A RESOLUTION PROVIDING COMMENTS ON A NORTH CAROLINA DEPARTMENT
OF TRANSPORTATION CONCEPT PLAN FOR IMPROVEMENTS TO JONES FERRY
ROAD

Draft Resolution No. 166/2011-12

RE: Follow-up Information on a Concept for Safety Improvements in the Jones Ferry Road Corridor

Figure 1. Topography (2 ft. contour intervals) along Jones Ferry Rd., east of Davie Rd.

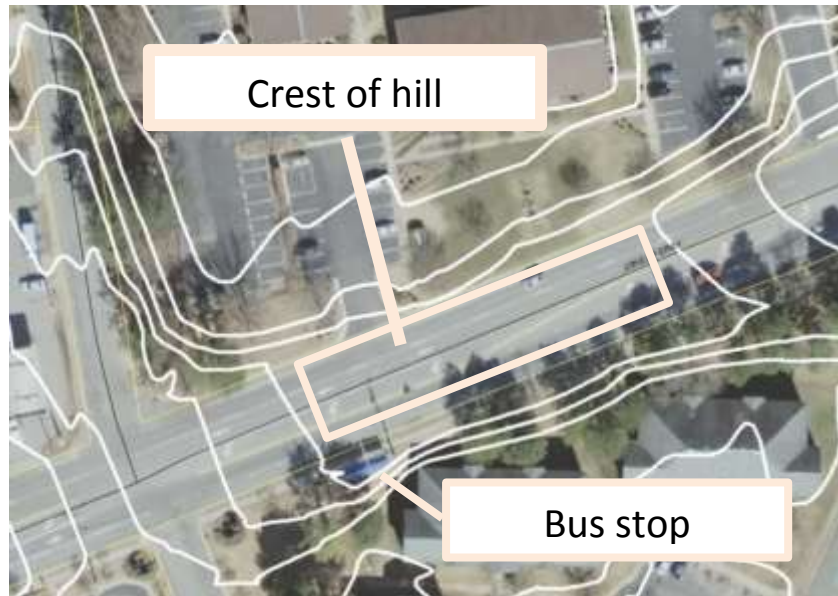
The bus stop in front of Abbey Court Apartments has the highest daily ridership of any bus stop within Carrboro town limits. In FY11, according to Chapel Hill Transit data, there was an average of 660 daily boardings or alightings, which ranked 20th in the Chapel Hill Transit system. The bus stop features two bus shelters, side-by-side, in the standard Carrboro design, located approximately 100 ft. east of the Abbey Court driveway. This location is within the crest of the hill along this section of Jones Ferry Rd., as shown in Figure 1. The contours show a gentler grade coming from the east to the crest of the hill than from the west.

Although occasional mid-block crossings from Ridgewood Apartments to catch the bus have been observed already, the bus stop is somewhat close to the Davie Rd. intersection. Relocating the bus stop to the east could potentially lead to an increased amount of mid-block crossings and reduce vertical sight distance for eastbound motorists. An advantage of the current location is that it is near proposed high-visibility crosswalks. Moving it further to the east would distance it from those crosswalks. It may also require substantial grading or construction of a retaining wall due to the steep downslope leading from the back of the sidewalk further east. There is a retaining wall to the west of the Abbey Court Apartments driveway which likely constrains the ability to relocate the stop there without the cost of demolishing part of the wall and grading for a new bus shelter.

Due to these challenges to relocating the bus stop from its current location, Town staff recommend that the current location be retained.

Figure 5. MUTCD recommendation for continuing a bike lane to the left of a right-turn only lane.

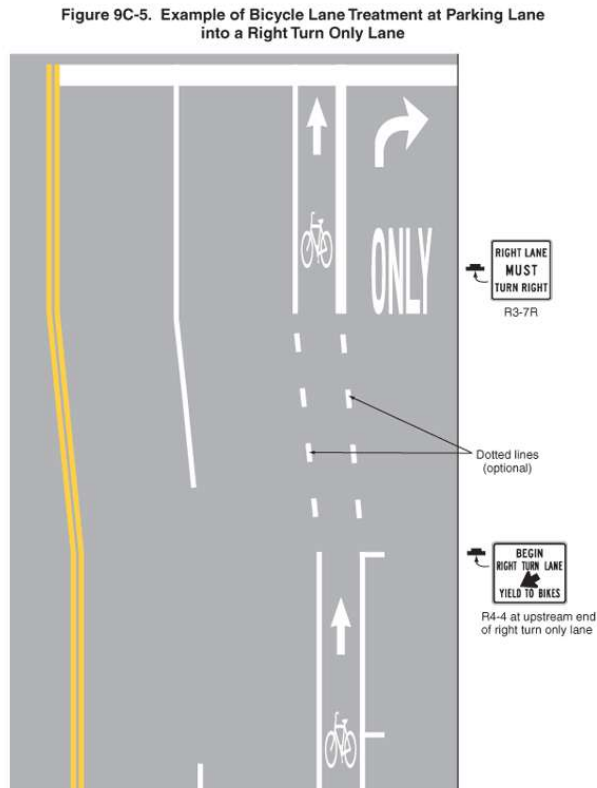
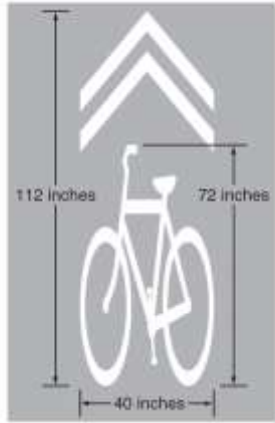
The TAB recommended that NCDOT should consider a protected bike lane, bike lane, or shared lane marking in the westbound direction west of Alabama Ave. Currently, there are three lanes in the westbound direction – two through and one combined-through-right. The concept plan drops the bike lane at Alabama Ave., in advance of the combined-through-right. It continues the same number of through lanes west of Alabama Ave., but replaces the center turn lane with a painted median and tapered left turn lane.

One of the options discussed by the TAB to continue the bike lane west would be changing the right lane to a right-turn-only lane, and then continuing the bike lane to the left of the right-turn only lane, as required by MUTCD Sec. 9C-04. This would be possible if there is enough room to fit the bike lane between the two travel lanes. West of the NC-54 westbound on-ramp, the facility could be continued as a bike lane or protected bike lane adjacent to the gutter pan. This would require removing the right-hand through lane.

**Figure 8. View of the NC-54 westbound on-ramp.**

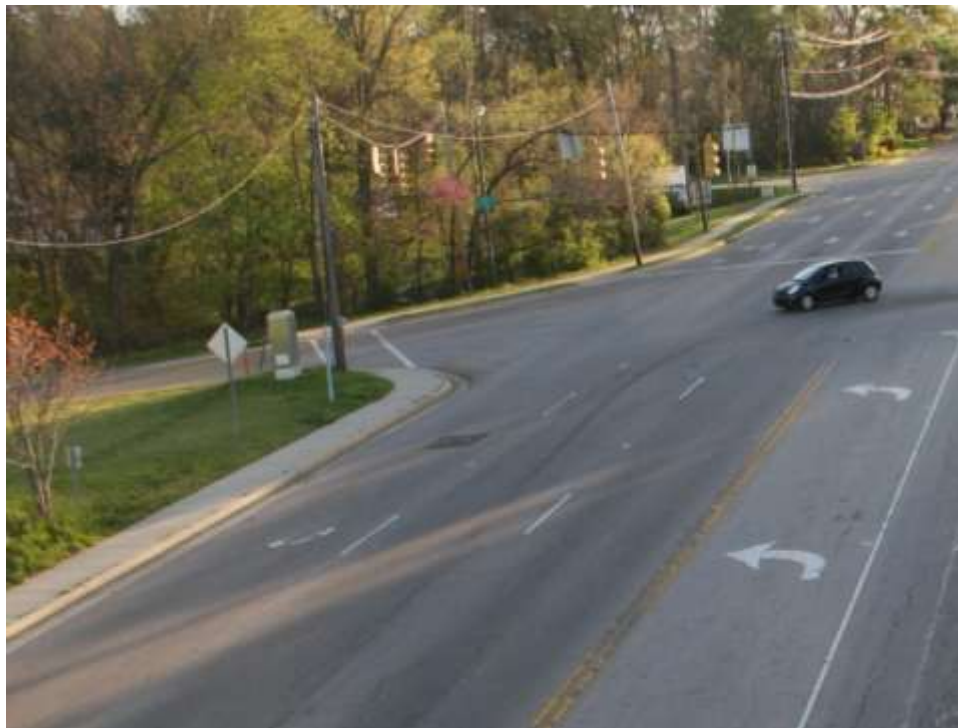
At its April 19, 2012, meeting, the TAB suggested that NCDOT explore reducing the curb radius at the NC-54 westbound on-ramp to calm vehicle speeds as they turn onto the on-ramp. The crosswalk is less than 100 ft. after the beginning of the turn. Figure 8 and Figure 9 show the existing turning conditions and a conceptual sketch of a sharpened curb radius, respectively. Staff concur that NCDOT should consider the feasibility of such a curb extension as part of the project.
